Canada Parks Agency
REHABILITATION LACHINE CANAL WALLS
CROWNING WALL REPAIRS AND REPLACEMENT
(SECTORS 5.2; 6 & E – BASIN N°3)
Project N° CLAC-1455-06
Addendum n° 01

MODIFICATIONS ON PLANS AND SPECIFICATIONS

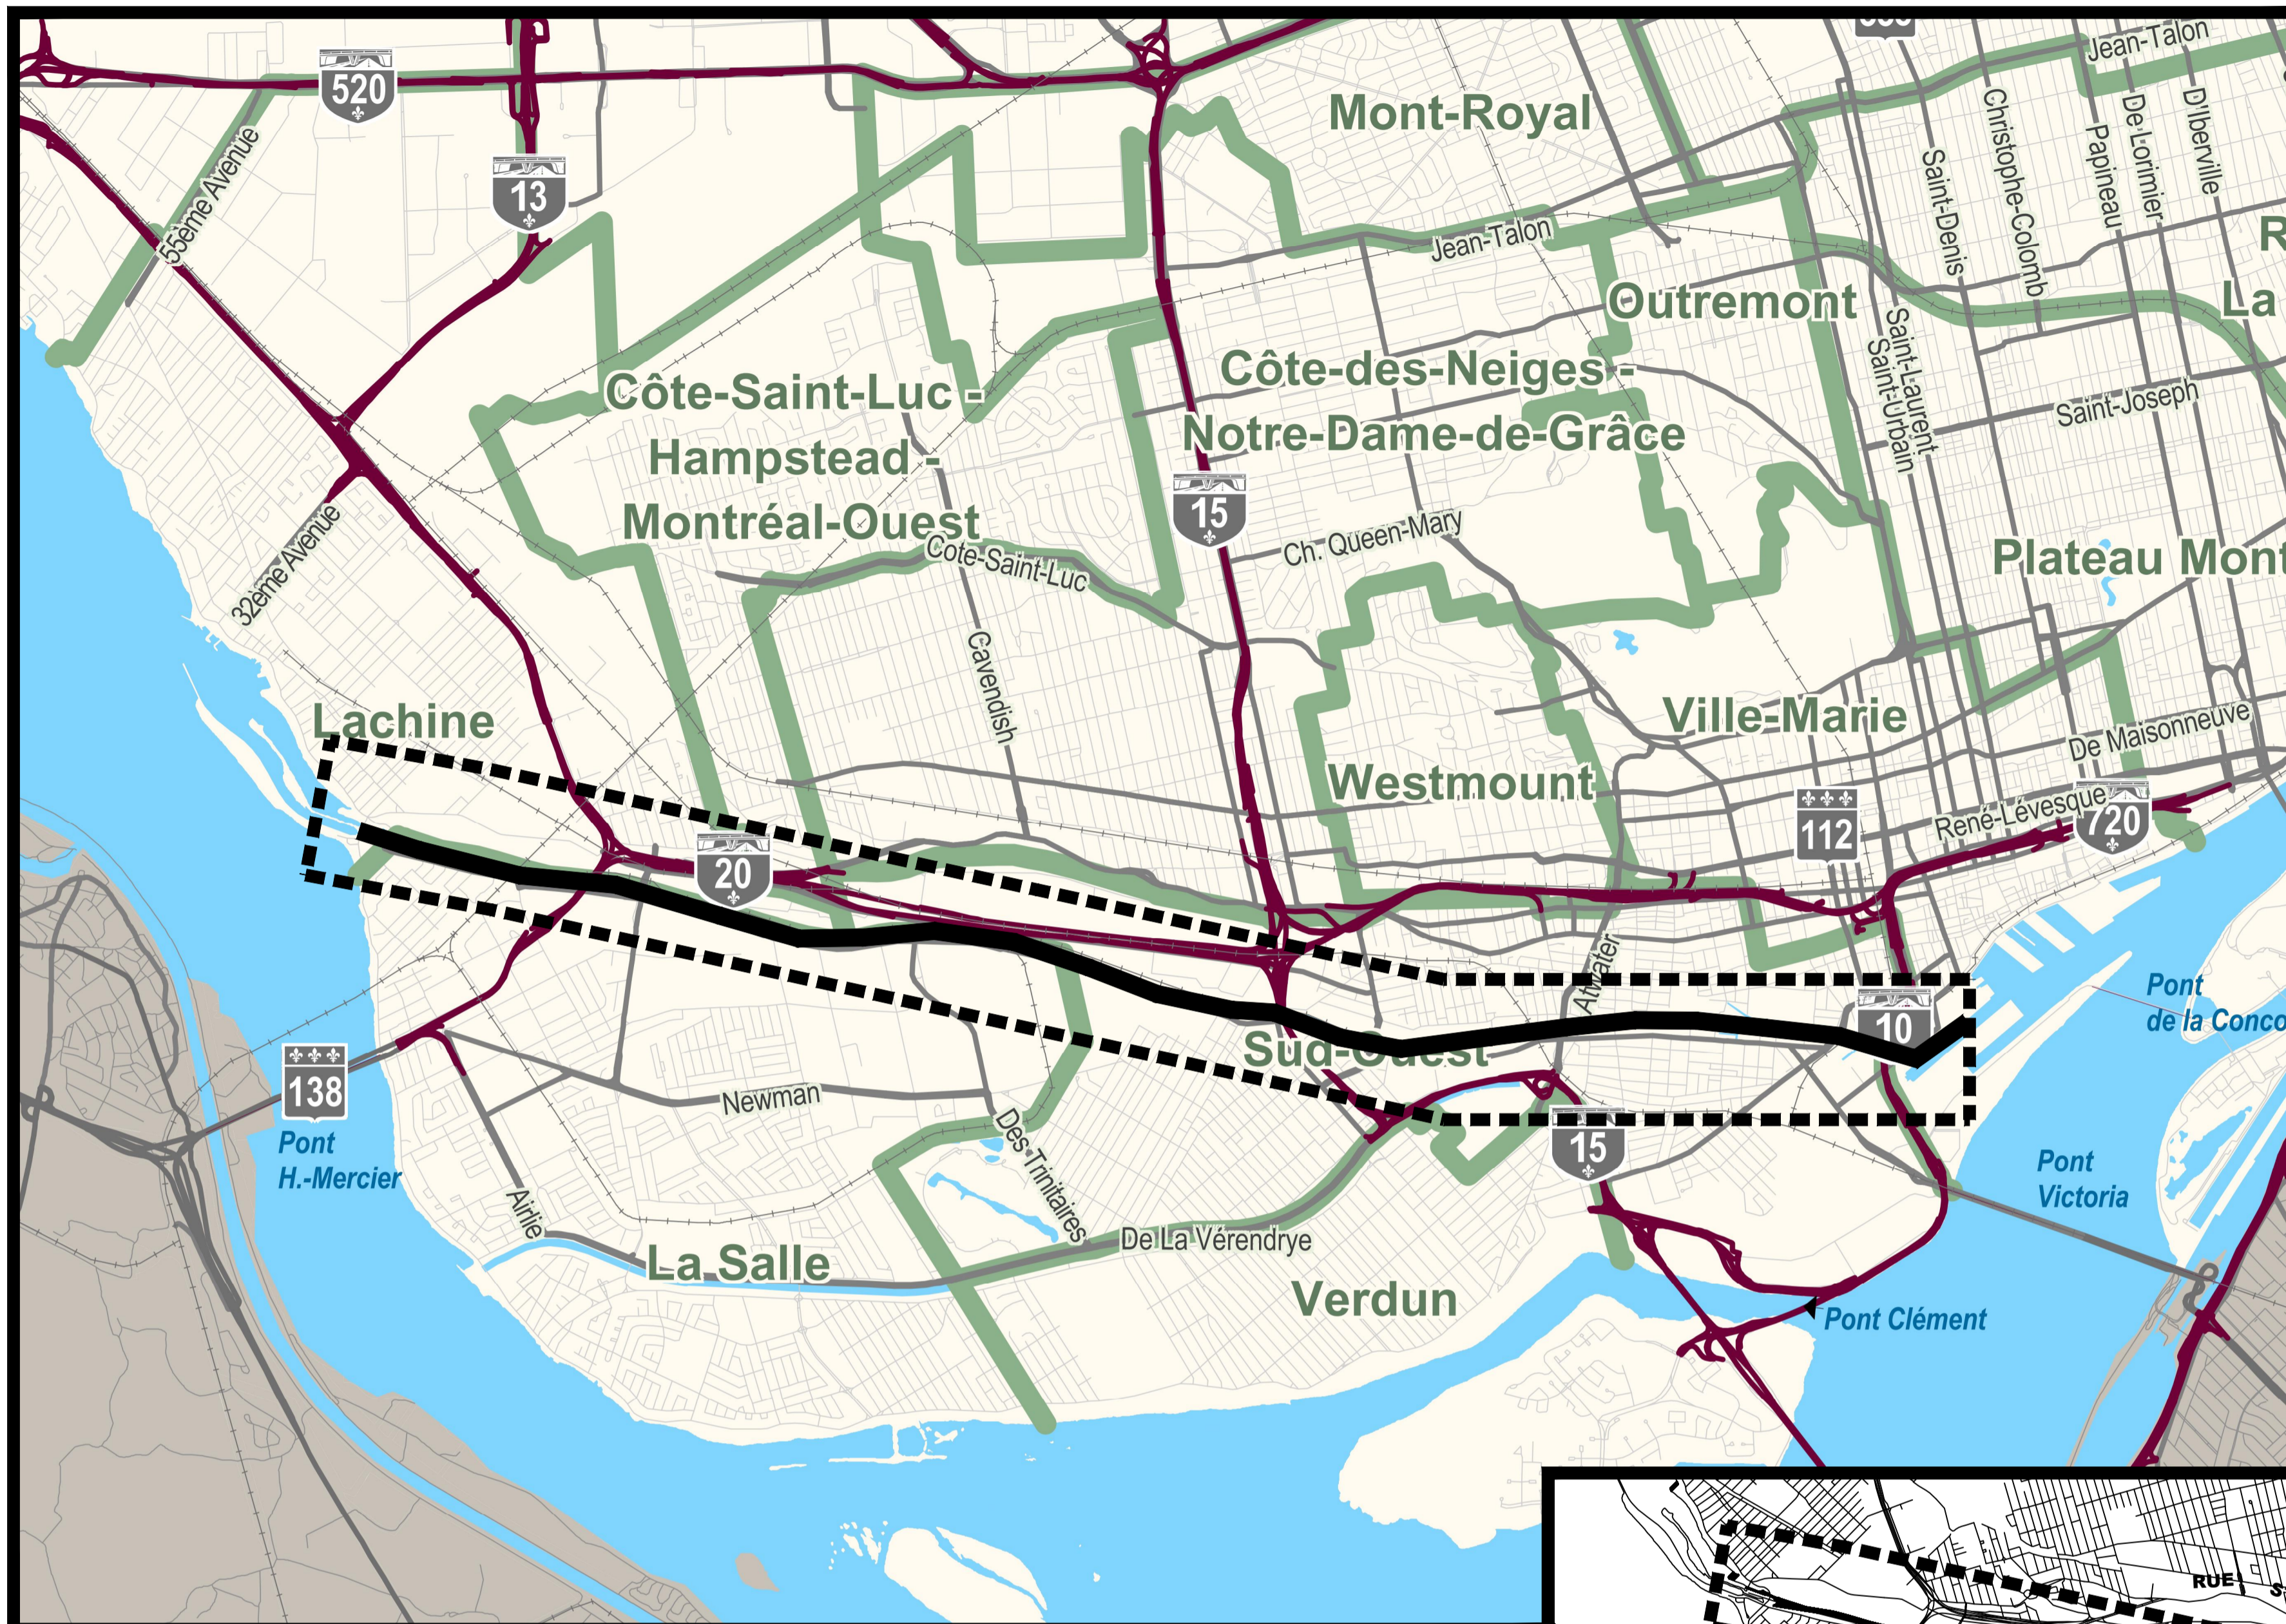
6.2 Do we have to put in place a 150mm or a 200 mm drain? The information seems to be divergent between the plans and the bid form?

The drainage system to be place behind the wall must be 200mm. This item is paid in linear meter at the article 2.11.

A square 150 mm drain also need to be must be put in place through the new walls in accordance with the details of the plan 19. The payment of this portion is included in the article 2.6 of the bid form,

Dessin
**STRUCTURE
 STRUCTURE**
 PAGE FRONTISPICE
 FRONT PAGE

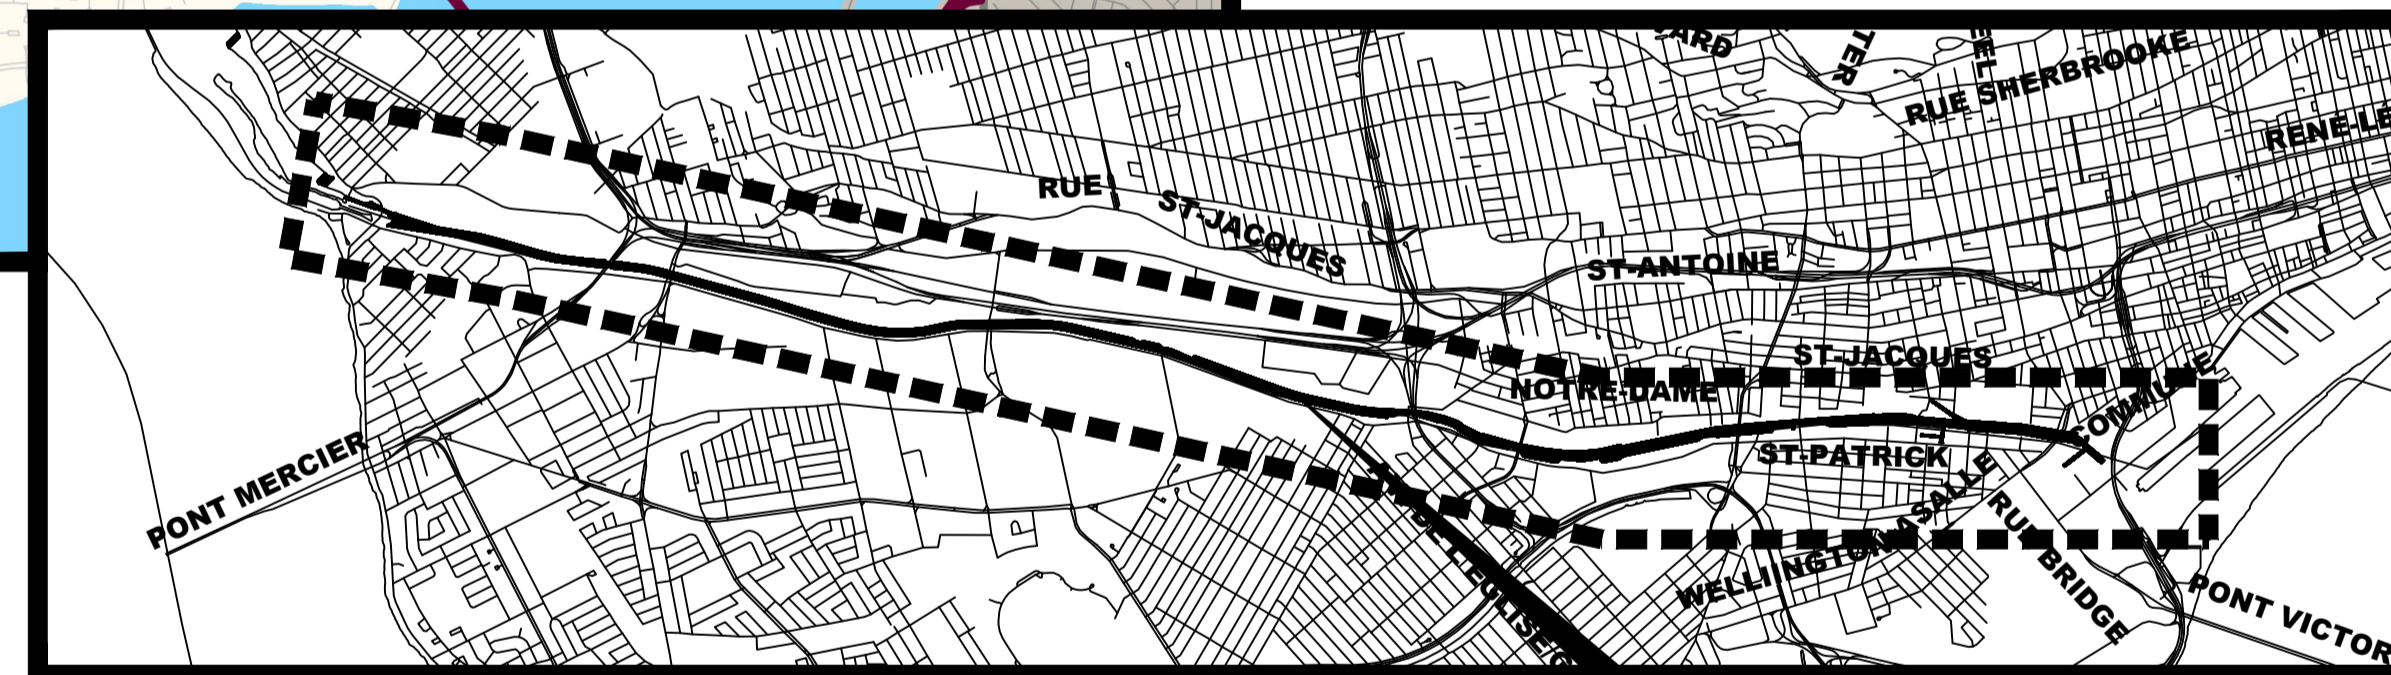
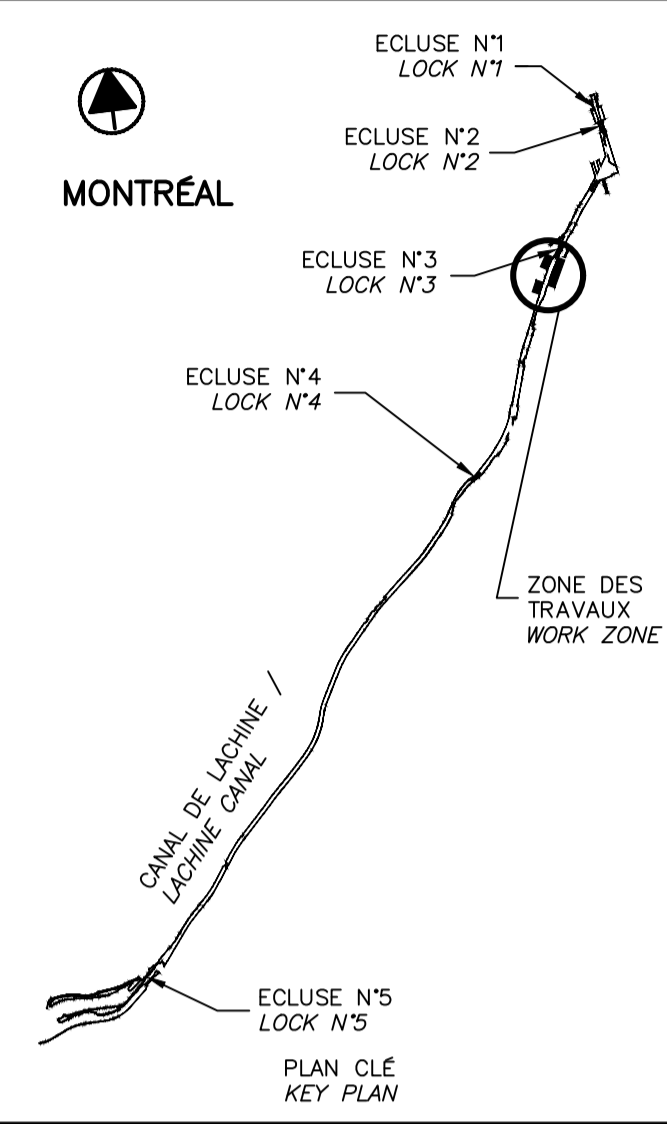
- 3.1 **Modifications on plans, sheet 01 is cancelled and replaced by sheet 01 revision 01:**

Added to the list of drawings and modification of the total page number of the drawings. See plans in annex. of this addenda

Dessin Drawing
**STRUCTURE
 STRUCTURE**
 ORTHOPHOTO
 ZONES DE TRAVAUX
 ORTHOPHOTO
 WORK ZONES

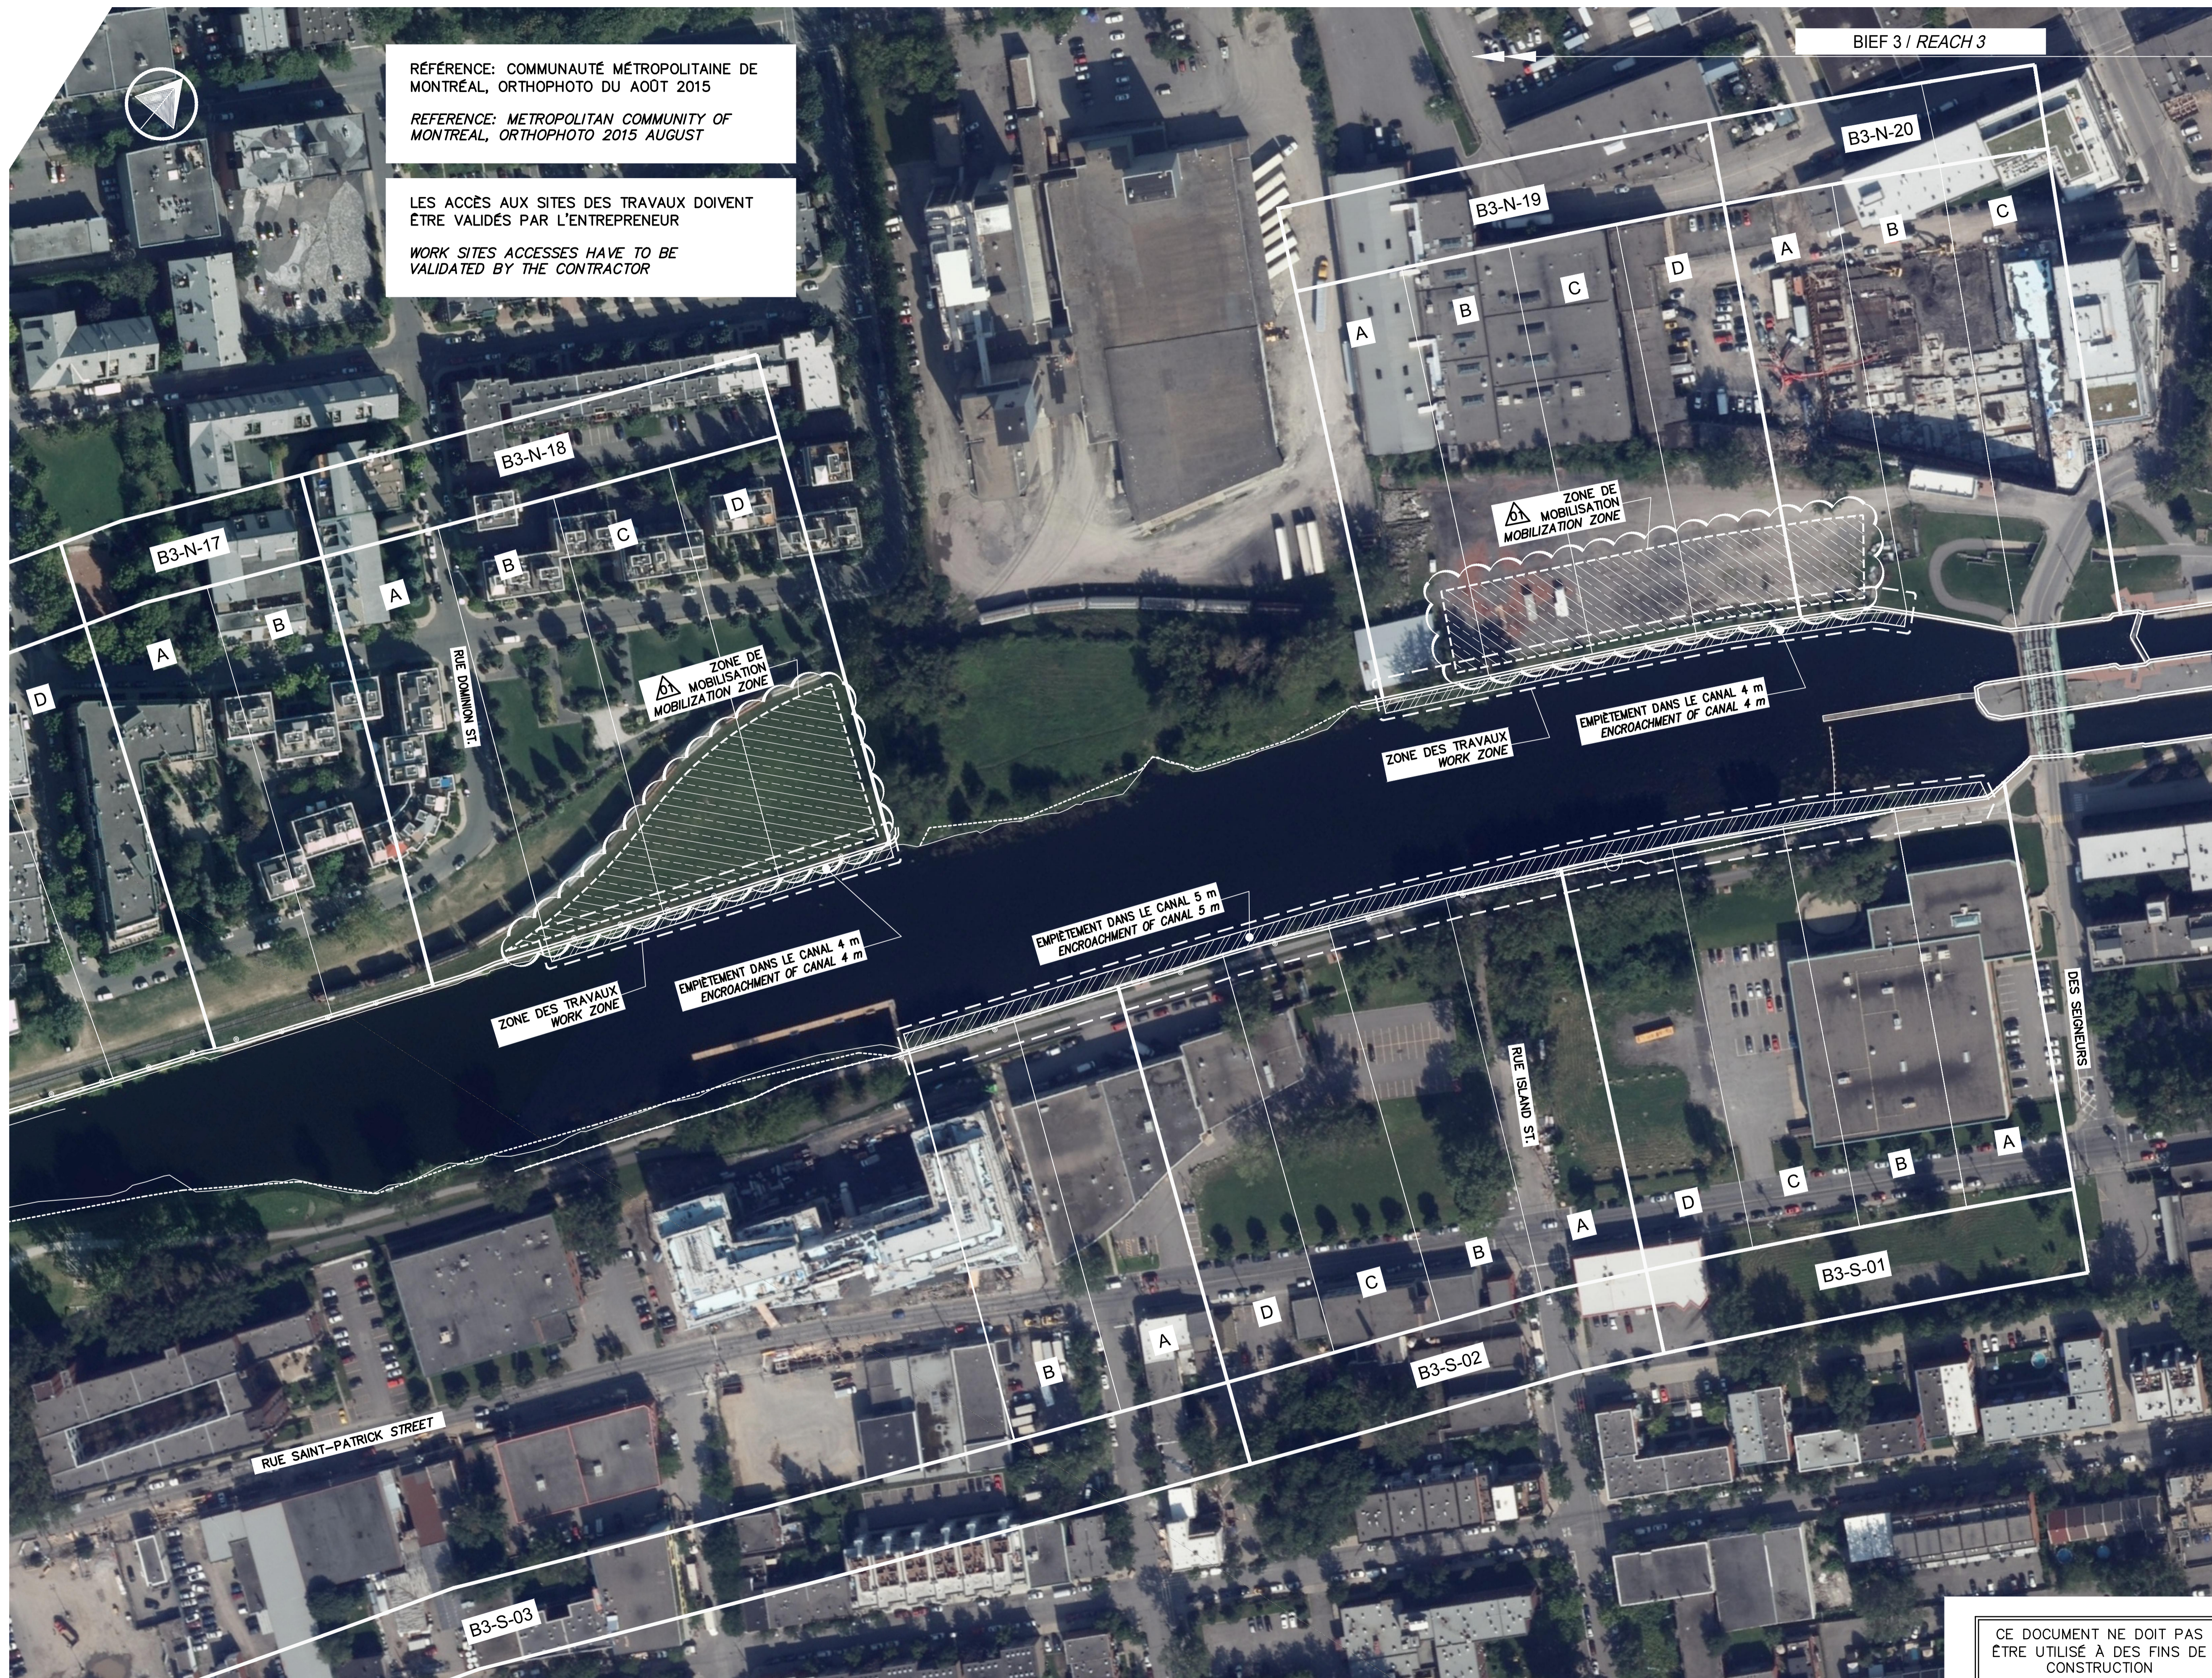
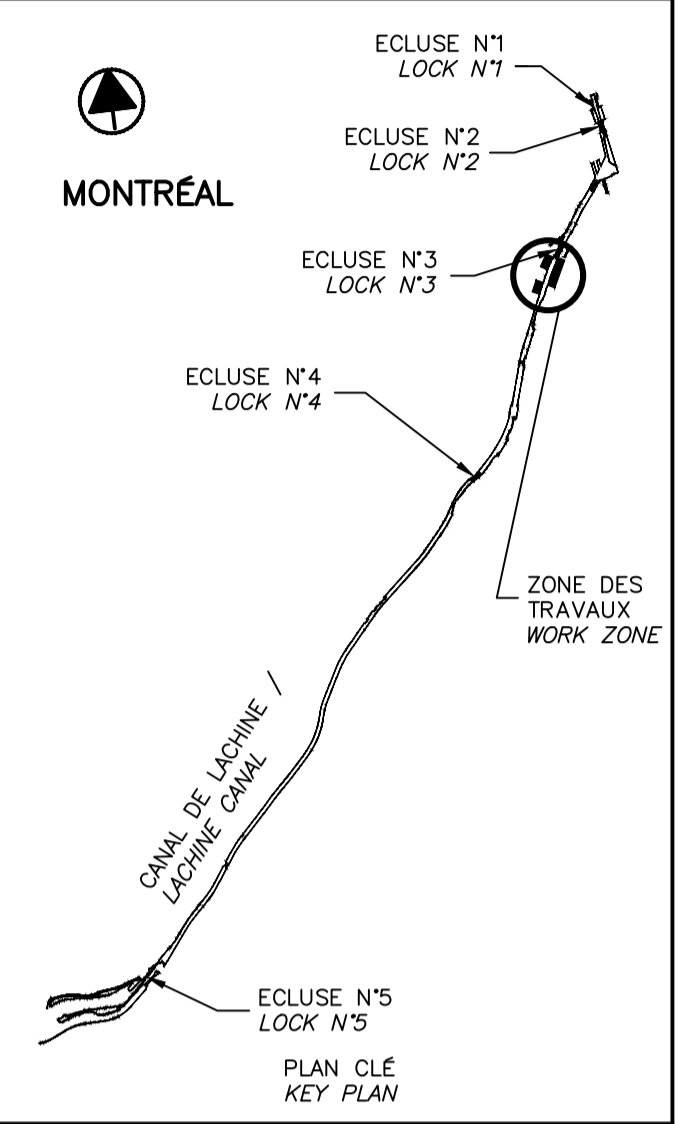
- 3.2 **Modifications on plans, sheet 08 is cancelled and replaced by sheet 01 revision 01:**

Mobilization zone are added to the plans. See plans in annex. of this addenda

- 3.3 **Modifications on plans, Adding sheets– Orthophotos :**

Addition of orthophotos indicating the limits of properties of the APC as well as zones of mobilization. See plans in annex of this addenda.
